TECHNICAL MEMORANDUM

TO: Laura Oliver, Deputy Recorder
FROM: Shay Stark, Planner
DATE: May 3, 2022
SUBJECT: 787 North Golden Eagle Way – Driveway – Planning Commission
PROJECT NO.:

787 N. GOLDEN EAGLE WAY

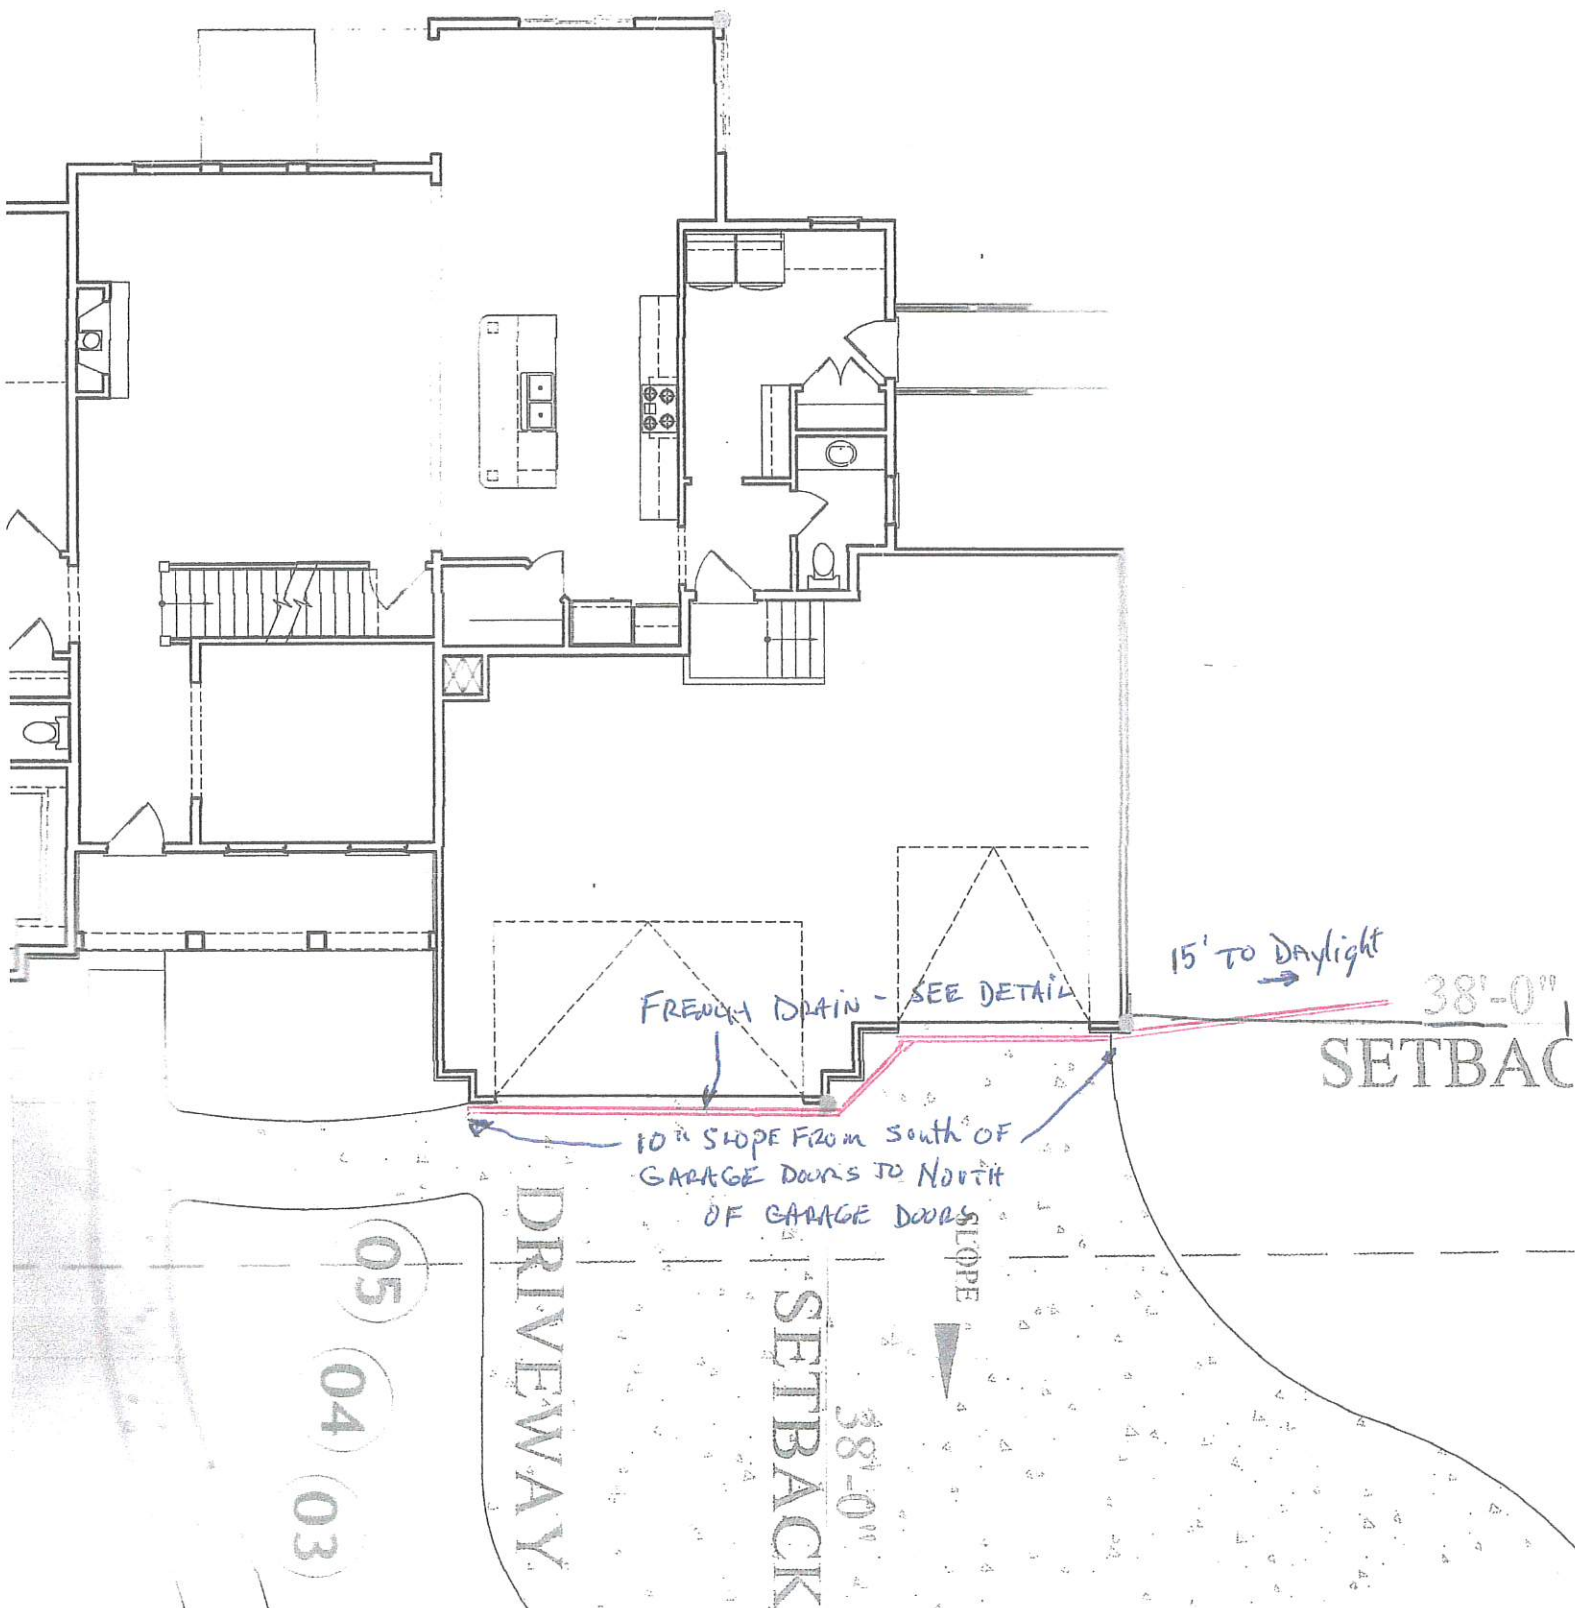
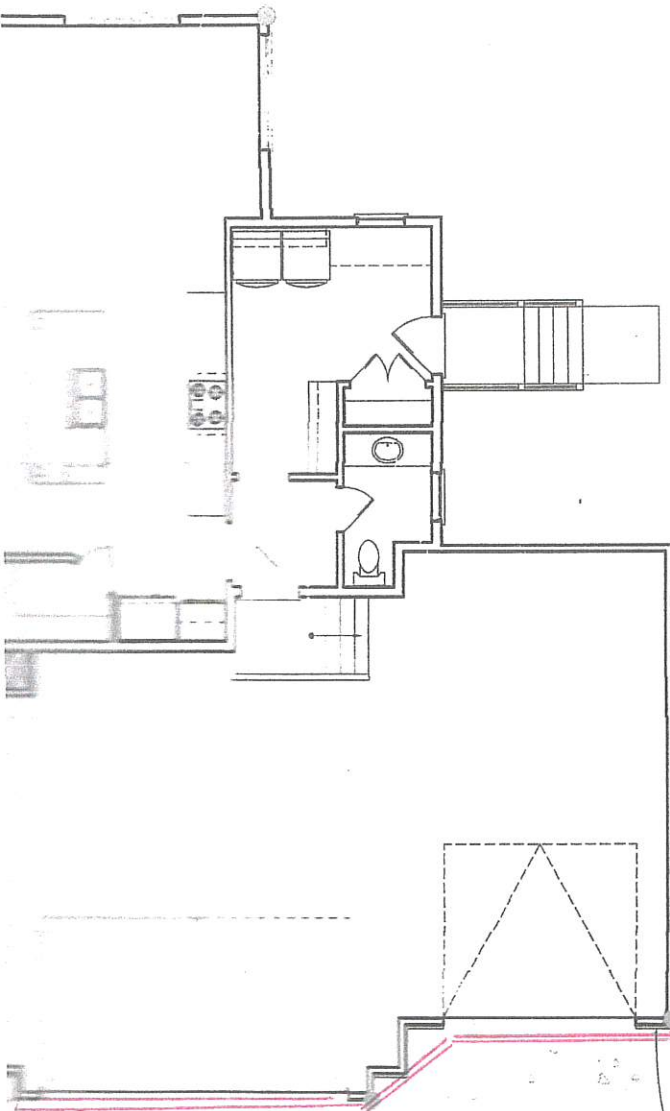
Per the drawings provided, Mr. Haskell has proposed the installation of a trench drain across the driveway, in front of the garage doors. The drain would be piped out to the north on the lot and a 12" high berm would be located along the north property line that would move the water to a depression or basin in the northwest corner of the lot. The area in between the drain outlet and the berm would be landscaped so there would be an opportunity for dispersion of the water and percolation. This part of the plan seems like it should work to keep the water out of the dwelling.

According to the provided plan. The water on the driveway runs to the northeast corner of the driveway. It would interesting to see what actually happens during a rainstorm to verify that this indeed is the location that all of the water flows to. If this truly is the case, then it is important to understand where the water travels from here. For example, on the north end of the Gladstan View Subdivision on Elk Ridge Drive there is a situation where runoff congregates, for a different reason, at one location on the back of a sidewalk. The water ends up running down the sidewalk and flooding neighbors' lots. If the sidewalk is the path of least resistance that is the direction the

water will travel. In this case I would suggest that a trench drain or drain box be located on the driveway in such a way to capture this water and send it into the on-lot basin if feasible.

In conclusion, Planning Commission may approve the reverse slope driveway if it can be shown that the surface water can be diverted away from the dwelling and can be directed so that it does not run on to neighboring properties. Drains and a pathway to an appropriately sized and located basin can solve this problem. The trench drain near the garage seems like a good solution to part of the problem. If expedience in a solution is more important than better understanding the actual flow of water on the driveway a trench drain or drain box at the low point in the entrance of the driveway on the lot behind the sidewalk is likely a safe solution.
